Report: TAB REPORT
Function: Test, Adjust, & Balance
Date: 09/18/2024
Completed By: National TAB

PROJECT
06-17-24 PENN STATION CLEVELS, OH

Project: 06-17-24 PENN STATION CLEVES, OH

MECHANICAL - FLOOR PLAN

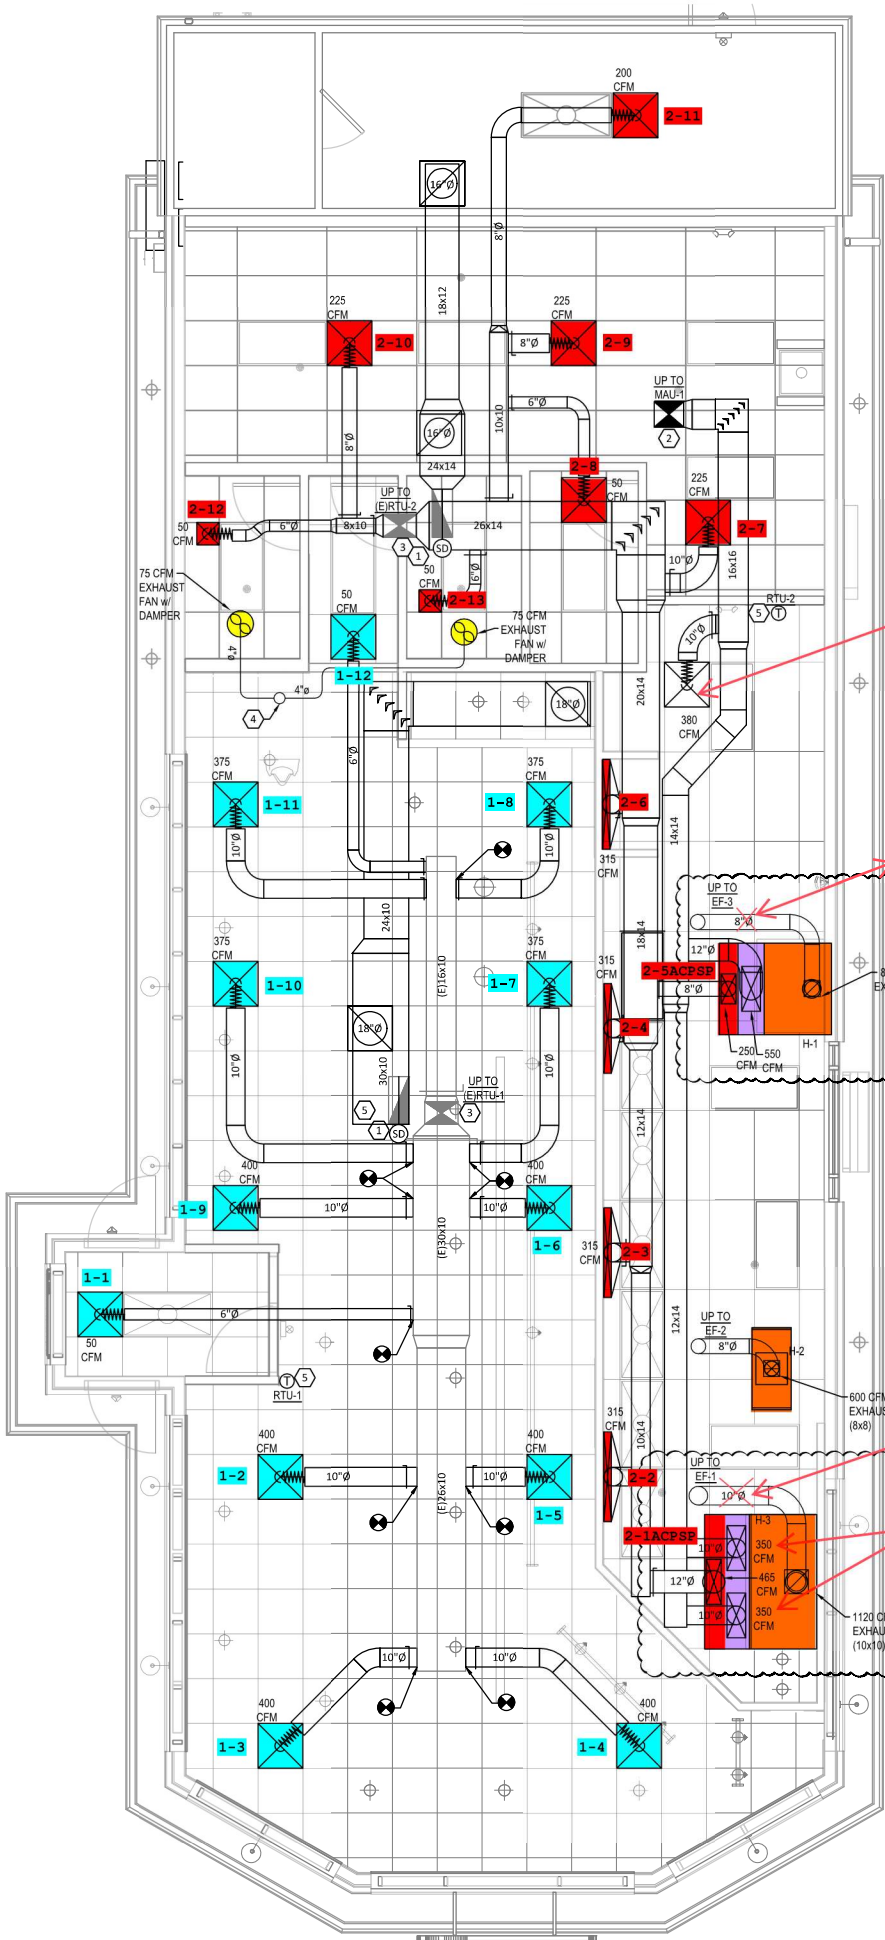
Recommended this be perforated. At times they install too close to hood & then causes performance issues if 4way. They dont always install exact location shown on prints, so fail safe.

To be 100 cfm Positive in pressure for building based upon RTU units OA amounts & including bathroom fan, & all hood exhaust we need the makeup air unit to have 1480 CFM of supply air. Adjusted CFM at hood.

total exhaust = -2720
rtu OA = + 1335
SF1 (mu) = +1460
net = +75 CFM

Recommended grease duct size for performance & sound ratings.

12" dia
455 CFM Each
